WESTGATE/BELVEDERE HOMES COMMUNITY REDEVELOPMENT AGENCY

Monday October 03, 2022 Board Meeting

2. Approval of DRO Application for Westgate Terrace 46-Unit Mixed-Use Development and Concurrent Type 2 Variances

Westgate CRA Board Meeting
October 3, 2022

Preliminary Site Plan

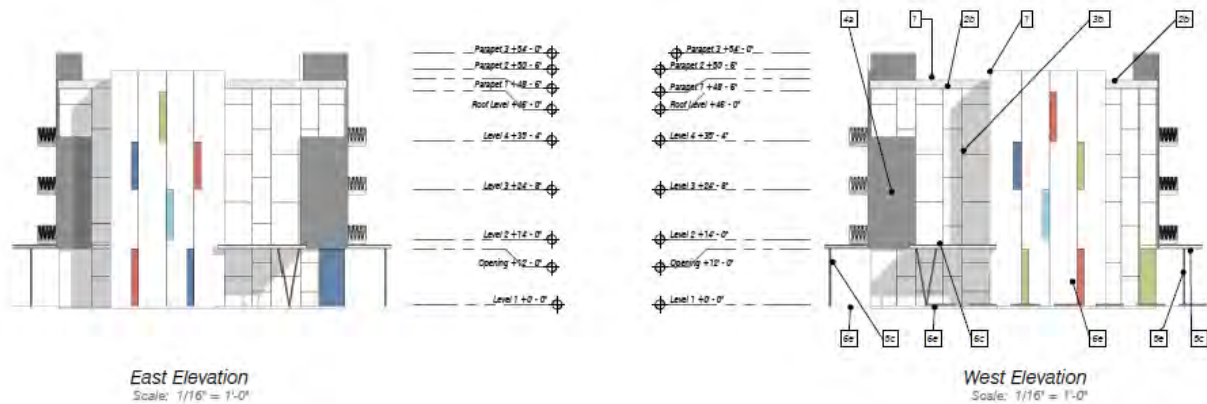
A development application is reviewed by the CRA for general conformity to WCRAO Sub-area use regulations, PDR's, design guidelines, and other Art. 3.B.14. standards. The Agency's review and comments occur in advance of a separate, more extensive review of the site plan and related application documents by the Zoning Division and other County departments once a project enters the entitlements process. A primary objective of the CRA's review is to consider appropriateness of use and consistency with the intent, goals, and visions of the CRA Redevelopment Plan. Staff must also contemplate projects in the redevelopment district in a way that facilitates economic development, and investor interest, with a critical eye that considers how a project will impact the community over the long term.

No fencing has been proposed along the Westgate/Seminole frontages to allow for direct access to the ground floor commercial spaces and main entrance. Fences and walls are prohibited in the front or side street setbacks for mixed use development in the NC Sub-area. A decorative aluminum fence with shrubs could be placed outside of the setback to provide security for the recreation area. WCRAO building entrance orientation standards stipulate that the main entrance be from the primary frontage street; based on the architectural elevations provided three main entries have been provided on the Westgate Avenue facing elevation; one for each of the commercial bays, and one for access to the residential lobby. These entries are mirrored on the south facing or rear elevation. Functionally, each of the commercial spaces have an individual entrance either at the front or rear of the building, so that residential activity is somewhat internally separated from commercial activities.

A landscape plan has not been provided but must be at building permit. ROW and incompatibility buffer widths are indicated on the site plan and do comply with code. WCRAO landscape deviations available to mixed use projects in the NC Sub-area have been applied, allowing a 50% reduction in the perimeter

buffer widths. Required foundation planting may be eliminated and relocated on site where a build to line is required pursuant to approval of an ALP by the DRO. Foundation planting is provided along 50% of the east facing elevation per Art. 7. The applicant is utilizing a WCRAO provision to reduce the recreational open space required by the Parks and Recreation Department by 50%; 5,000 sf is provided at the east of the site. The architect has provided some landscape reference images for a children's play area, gazebo, splash pad and benches.

WCRA overlay regulations provide a substantial reduction from residential and commercial parking requirements. Article 6 requires 2 parking spaces per unit (one bedroom or more), plus 1 space per 4 guests for multi-family developments. Based on these regulations the parking required is impossible to reach and a variance request would be necessary. WCRAO parking deviations for residential projects (Table 3.B.14.I.) allow for the required number of parking spaces to be reduced. Article 6 offers an option to waive a maximum 15% of the required number of parking spaces through a Type 1 Waiver process. 117 parking spaces would be required utilizing the deviations allowed by WCRAO code, and 100 spaces are proposed. The applicant has applied the full 15% maximum waiver to reduce the parking requirements by 17 spaces, allowing for more onsite retention and a larger outdoor recreation area. The parking counts include 8 on street parking spaces based on the design of the upcoming Westgate Avenue streetscape project. Bike rack parking areas have been provided and ADA compliant spaces have been provided directly adjacent to the building. Art. 6 requires one loading zone at 12 ft. wide x 18.5 ft. long for projects with over 10,000 sf of commercial, but the provision also allows the use of parking spaces and the drive aisle in lieu of providing a designated loading space during off- business hours.

A 5 ft. perimeter walkway runs immediately adjacent to the building on 3 sides: front, west elevation, and rear, providing pedestrian connectivity to entrances on both the front and rear. Access to the site is from Seminole Boulevard and Nokomis Avenue. Parking and access is required at the rear of a site where available in the NC Sub-area. Land Development will require the applicant to process a standalone subdivision variance for the Nokomis Avenue access due to the 40 ft. ROW width and commercial use type. It should be noted that the applicant may have to provide a cross access between sites as a requirement of the URA which may be applicable to this project.

Architecture & Design

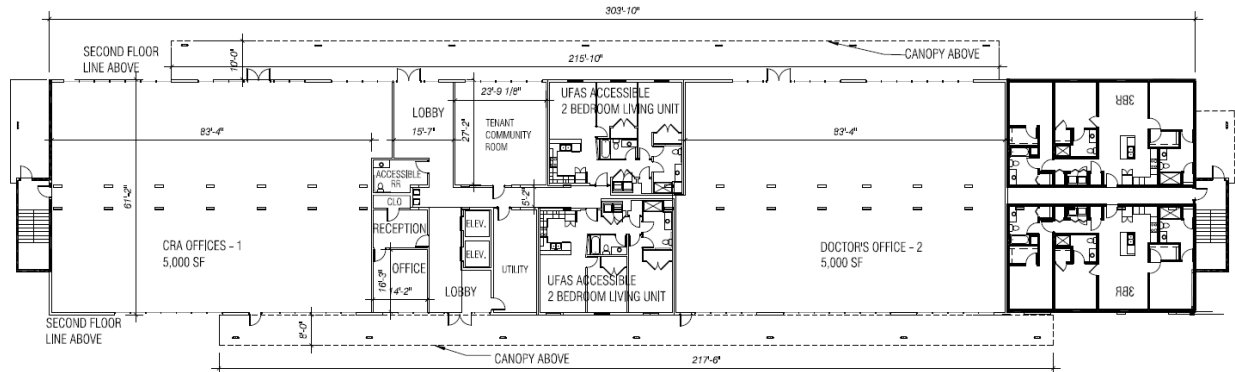
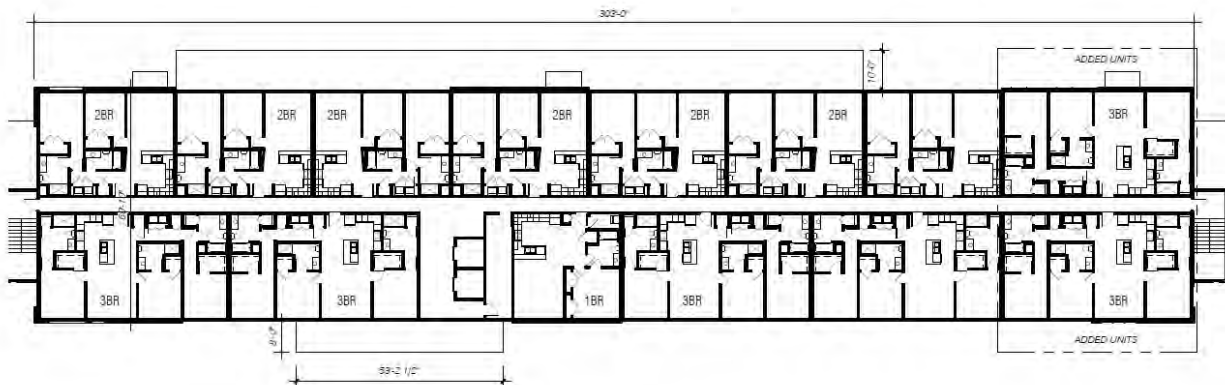
All mixed-use projects in the WCRAO must be reviewed for compliance with the architectural standards in Art. 5, as well as the architectural guidelines and supplementary standards of the WCRAO. The project is fortunate to have Zyscovich Architects on the development team. Headquartered in Miami, the firm is nationally and internationally renowned for a distinctive modern style. Its many projects in South Florida include the Brightline stations, Miami Beach Convention Center, and the Wynwood Quarters. The applicant has provided architectural elevations and a ground and 2nd, 3rd & 4th floor plan for the building design. At building permit, compliance with the standards of Article 5 will be required. The architecture incorporates a modern aesthetic with graphic elements, angular design features, a modern flat roof line, and recesses and projections in contrasting colors for architectural interest. The building color is white with grey accents. Primary colors emphasize the façade, adding a playfulness and whimsy. The gallery
